NRC RAI Letter No. PTN-RAI-LTR-041

SRP Section: 02.05.01 - Basic Geologic and Seismic Information

QUESTIONS from Geosciences and Geotechnical Engineering Branch 2 (RGS2)

NRC RAI Number: 02.05.01-7 (eRAI 6024)

Figure 1 Locations of Storm Deposits in Southern Florida

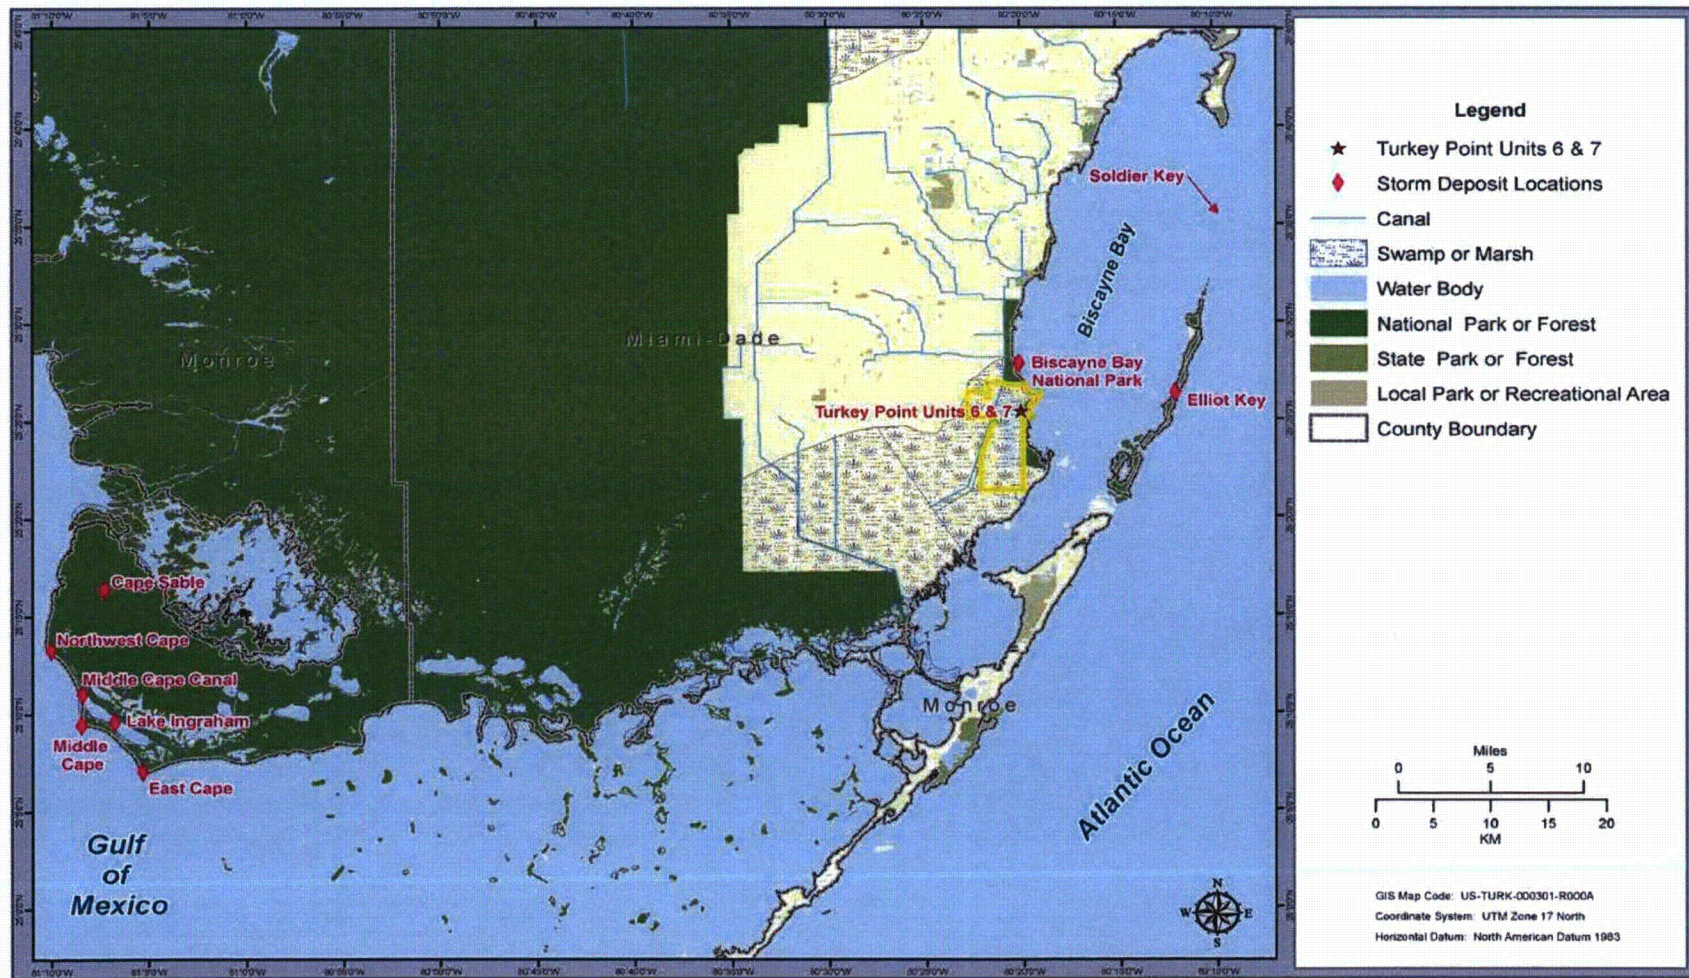
- a) Within the context of the Holocene sedimentary record at the site discuss the nature and extent of paleostorm deposits.
- b) Provide a discussion that compares and contrasts deposits of Hurricane Andrew or other historical hurricanes, and any paleostorm deposits preserved in the Holocene stratigraphy, with potential tsunami deposits at the site.
- c) Provide a figure or a map that illustrates these deposits.

Although preserved storm deposits have not been observed at the Turkey Point Units 6 & 7 site, storm deposits have been observed elsewhere in southern Florida. Storm deposits have been preserved at scattered locations on the east coast of Florida at Biscayne Bay and Soldier Key to Elliot Key. Similar deposits are documented on the west coast at Northwest Cape and Cape Sable in the Gulf Coastal Highlands of the Reticulated Coastal Swamps Physiographic Subprovince. This physiographic subprovince is shown on FSAR Figure 2.5.1-217 and the locations of preserved storm deposits are shown on Figure 1.

Since there are no paleostorm or paleotsunami deposits preserved or observed in the borings at the Turkey Point Units 6 & 7 site, there are no data from which a map can be generated. FSAR Figure 2.5.1-337, Surficial Deposits Map, shows the soils to be disturbed at the footprint of the proposed Turkey Point Units 6 & 7 and the existing cooling canals. As discussed in the response to part (b), storm deposits are only intermittently preserved in southern Florida. Storm deposits are preserved at scattered locations in southwest Florida (Reference 3) and on the shorelines of Biscayne Bay (Reference 4). The examples of storm deposits documented by Wanless and Vlaswinkel (Reference 3) and Swiadek (Reference 4) are discussed in part b) of this response and the locations are shown in Figure 1.

Figure 2.5.1-229 Regional Tectonic Features

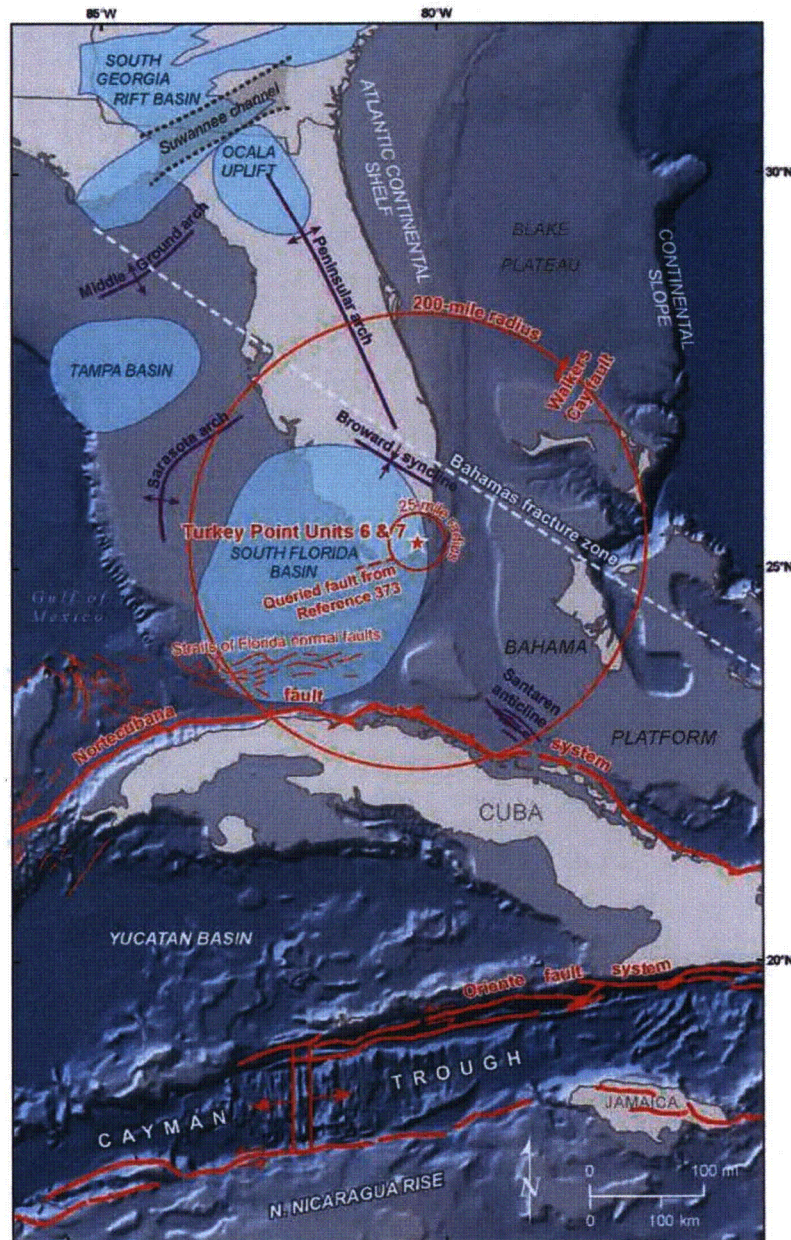
As described in FSAR Subsection 2.5.1.1.1.3.2.2 and RAI Response 2.5.1-16, the Straits of Florida normal faults were primarily active in the Eocene and acted to thin the overthickened wedge of foreland material shed off the colliding Greater Antilles arc (FSAR 2.5.1 References 221 and 482) (FSAR Figure 2.5.1-229). These structures were active in the Eocene and show very little evidence for younger deformation (Figure 2.5.1-209) though some may have been reactivated in response to far-field effects of collision in

FSAR Figure 2.5.1-229 will be revised in a future COLA revision to include a label for the Straits of Florida normal faults as shown below:

Figure 1. Figure 5 from Cunningham et al (1998); Stratigraphic correlation diagram across southern Florida.

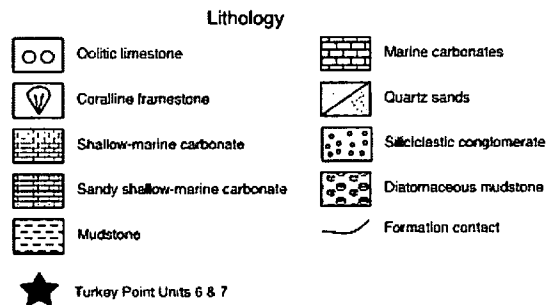
- a) Substantiate your interpretation with specific evidence that the stratigraphic relations across the queried fault shown in Figure 2.5.1-234 and depicted in Reference 373 are a result of paleo-topographic or karst processes, rather than tectonic offset.
- b) If the queried fault is indeed a fault, please discuss the timing and spatial extent of faulting and update the FSAR discussion accordingly.

Figure 1 is a modified version of FSAR Figure 2.5.1-234 that shows a cross-section across southern Florida (Figure 5 of Cunningham et al. [1998]). This cross-section was developed with data from eight wells in southern Florida. Between the southernmost two wells, Cunningham et al. (1998) postulate the existence of a fault that cuts up through Avon Park Formation, Suwannee Limestone, and Oligocene-Miocene-age Arcadia Formation, and potentially places the Arcadia Formation in fault contact with the lower portion of the overlying Miocene-Pliocene Long Key Formation. Alternatively, the Long Key Formation may be interpreted as deposited across a paleoscarp. Cunningham et al. (1998) label the postulated fault on this cross-section with two question marks,

The queried fault on Cunningham et al.’s (1998) Figure 5 (FSAR Figure 2.5.1-234) is drawn to explain thickness and stratigraphic variations. These variations may instead be related to paleotopography, indeed, the top of the Arcadia Formation is known to have significant paleotopographic variation. On Key Largo, relief on the top of the Arcadia Formation as large as 40 meters was found between borings only a few kilometers apart (Warzeski et al., 1996). Furthermore, in Cunningham et al.’s (1998) Figure 4 (Figure 4), the elevation of the top of the Arcadia Formation varies by approximately 100 meters between wells W-3174 and W-17086 (88 km apart), by 50 meters between wells W-17156 and W12554 (56 km apart), and by 25 m between wells W-3011 and W-17157 (2 km apart). The slope required to achieve this latter elevation variation, 0.7 degrees, is actually greater than the slope required to achieve the elevation variation observed in the Arcadia Formation between the Everglades Park and Gulf Oil wells, where the queried fault is depicted in Figure 5 of Cunningham et al. (1998) (approximately 100 meters over 18 kilometers of distance, or a 0.3 degree slope). Numerous other examples exist throughout southern Florida of steeper paleotopographic slopes on the top of the Arcadia Formation that are not associated with faulting. In addition, the down-to-the-south separation depicted on the postulated fault in Figure 1 is consistent with, and may, in part, be attributed to the regional southward dip of the strata towards the South Florida Basin in the area (e.g., Miller, 1986; Figure 6). Similarly, the increase in the thickness of clastics south of the fault is consistent with thickness variations seen throughout southern Florida associated with proximity to the “coarse sand channel” (Figure 2).

Figure 2.5.1-229 Regional Tectonic Features

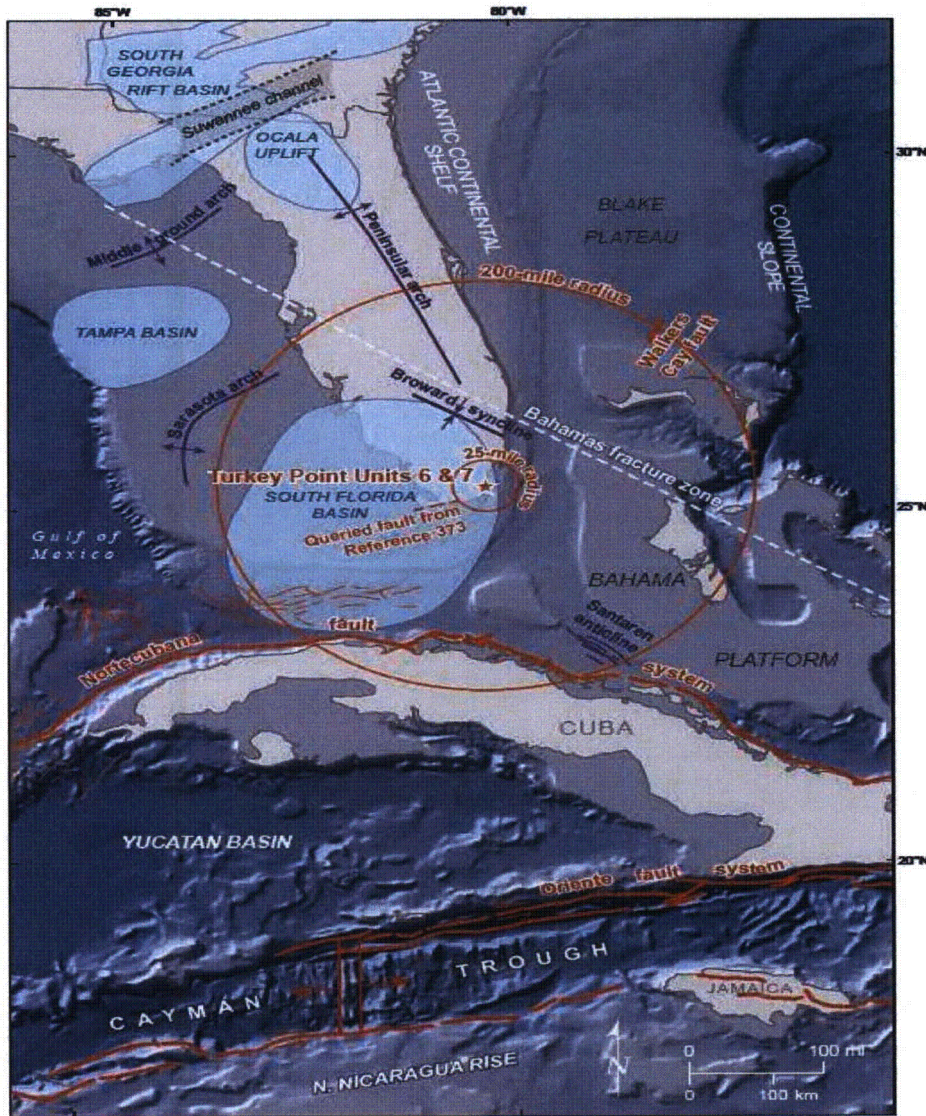
FSAR Section 2.5.1.1.1.3.2.1, "Structures of the Florida Peninsula and Platform" states that occasional variations in pre-Miocene stratigraphy recorded in boreholes due to erosion-based paleo-topography or karst have sometimes been interpreted as possible faulting; for example, the queried fault in Figure 2.5.1-234 (between wells Park W-2404 and Gulf W-3510) appears to displace the base of the Long Key and Arcadia Formations at approximately 100 m and coincides with nearly a doubling in thickness of the Long Key Formation on the downthrown (southern) side. The staff notes that the fault juxtaposes the Long Key Formation against the Arcadia Formation and the Arcadia Formation against the Avon Park Formation. Cunningham et al., 1998 (Reference 373) also provides a structural contour map of the top of the Arcadia formation and a map of net thickness of Miocene-to-Pliocene siliciclastic sand that appears to be consistent with faulting (Figure 17 of Cunningham et al., 1998).

Cunningham et al. (Reference 373) postulate that a fault or paleotopography could be responsible for elevation variations in the Arcadia formation in southwestern Florida (Figure 2.5.1-229). The queried structure is between 50 and 60 kilometers long (30–37 miles) (Figure 2.5.1-229), and at its nearest approach, the eastern end of the queried fault is approximately 41 kilometers (25 miles) west of the Turkey Point Units 6 & 7 site.

The following figure will be revised in a future COLA revision:

Figure 5 Interpretation of LBB-18. Uppermost cross-section modified from Harwood and Towers' (1988) (FSAR 2.5.1 Reference 476) Figure 6. Lower left cross-section from Austin et al.'s (1988b) (FSAR 2.5.1 Reference 785) Figure 5.

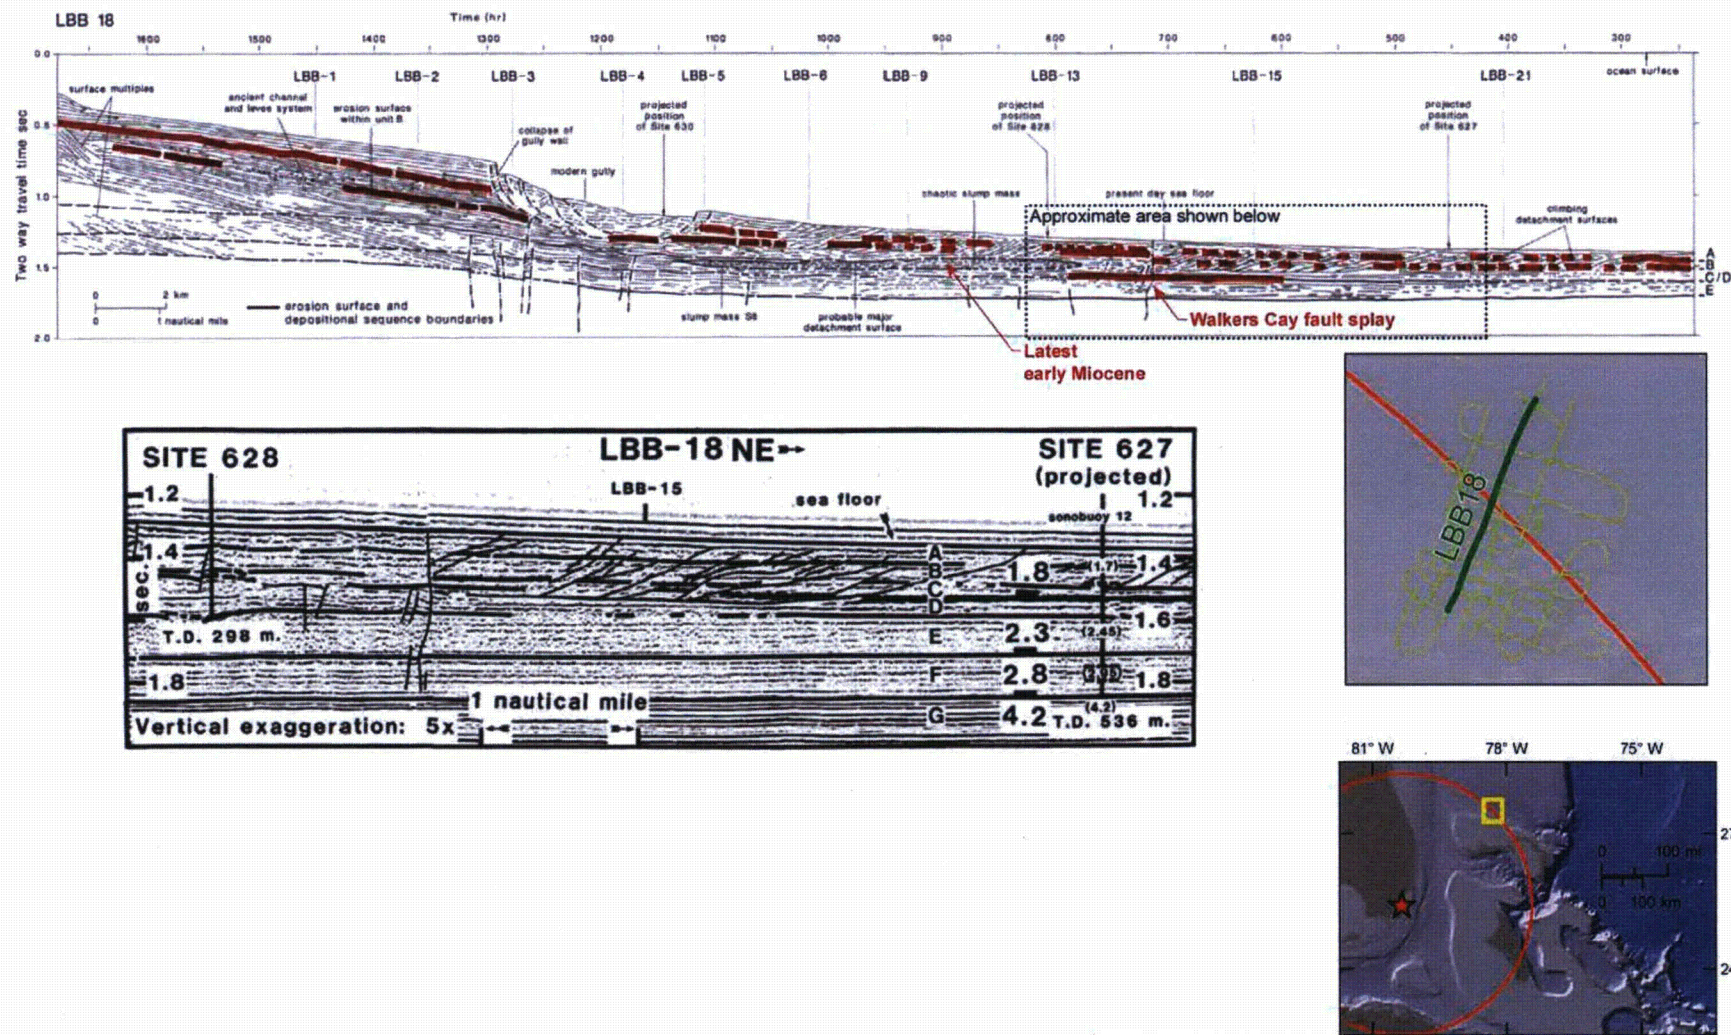
- 1) Label Walkers Cay fault on FSAR Figure 2.5.1-276.
- 2) Explain the basis for Harwood and Towers (1988) conclusion within the limits of resolution for marine seismic reflection data.

Seismic line LBB-18 is oriented north-northeast, parallel to, and west of, seismic line LBB-17 (Figure 1). The interpreted version of seismic line LBB-18 from Harwood and Towers (1988) (FSAR 2.5.1 Reference 476) is shown in the upper panel of Figure 5, which depicts a normal fault extending upward to the seafloor at approximately 700 hrs. This unnamed fault is possibly the Walkers Cay fault, although Harwood and Towers (1988, p. 266) (FSAR 2.5.1 Reference 476) indicate that it is "a minor splay." The lower left panel of Figure 5 shows Austin et al.'s (1988b) (FSAR 2.5.1 Reference 785) interpretation of the portion of seismic line LBB-18 that includes this same normal fault strand. Austin et al. (1988b, p. 401) (FSAR 2.5.1 Reference 785) state, "This fault may still be active, as it appears to offset the seafloor." No statements regarding the amount of offset in Quaternary strata, or the thickness of the Quaternary section, are provided by Austin et al. (1988b) (FSAR 2.5.1 Reference 785) or Harwood and Towers (1988) (FSAR 2.5.1 Reference 476). Previous publications on analysis of cores (Austin et al. 1986a, 1986b, 1986c), however, indicate that three borings along LBB-18 demonstrate the Quaternary section ranges from 3.6 m to 18.2 m in thickness (Figure 1b).

In summary, on only one of the five presented seismic lines that cross the Walkers Cay fault (LBB-18) do the authors interpret a fault reaching the seafloor (Figure 5) (Austin et al. 1988b) (FSAR 2.5.1 Reference 785). This is consistent with the summary of seismic lines collected in ODP Leg 101 that states that "throughout the area it [the Walkers Cay fault] has only a minimal effect on sediments younger than middle Miocene" (Harwood and Towers 1988, p. 266) (FSAR 2.5.1 Reference 476). The possibility of Quaternary slip on the Walkers Cay fault cannot be precluded by the available data.

Figure 2.5.1-350 Regional Seismicity Plotted on a Map of the Nortecubana Fault and Santaren Anticline

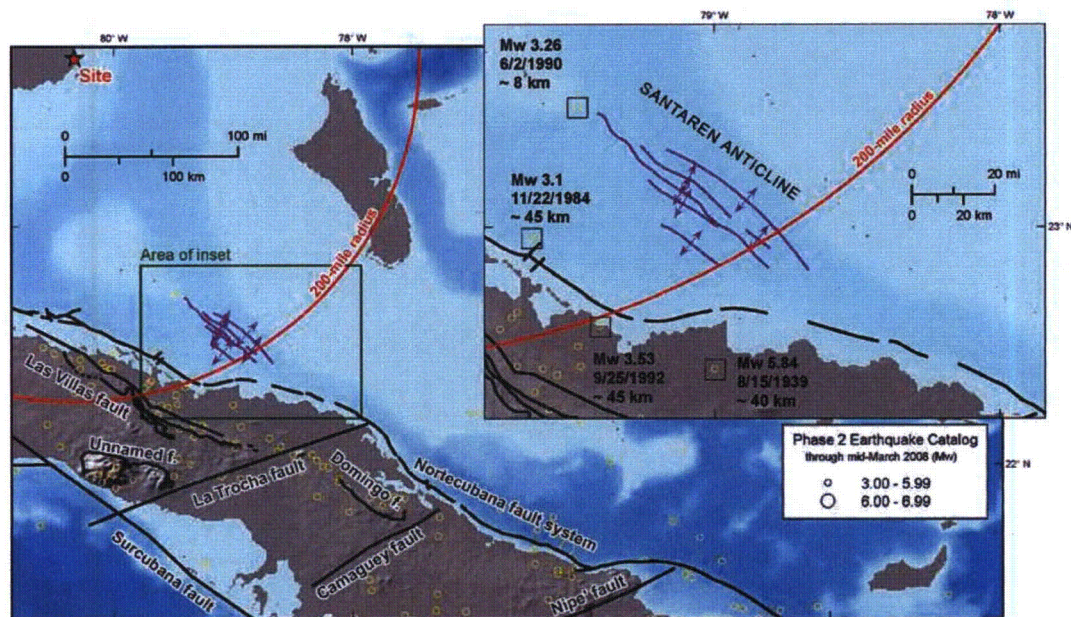
The Phase 2 earthquake catalog provides some insight into modern-day associations. As discussed in the FSAR, seismicity along the Nortecubana fault is concentrated near its intersection with the Oriente fault and substantially decreases northwestward into the site region (FSAR Subsection 2.5.1.1.1.3.2.4). Seismicity in the vicinity of the Santaren anticline, discussed in part (b) of this response, is sparse. Based on the Phase 2 earthquake catalog, there is only one earthquake that is on-trend with the Santaren anticline, and that event is located approximately 40 km to the west. There are no recorded earthquakes or mapped structures found in the literature in the approximately 30-km-wide gap between the Santaren Anticline and the Nortecubana fault system (Figure 3). Given the lack of data suggesting a structural link between these features, there is no reason to conclude that the Santaren anticline and the Nortecubana fault system are linked.

The following figure will be added as a new FSAR figure in a future COLA revision:
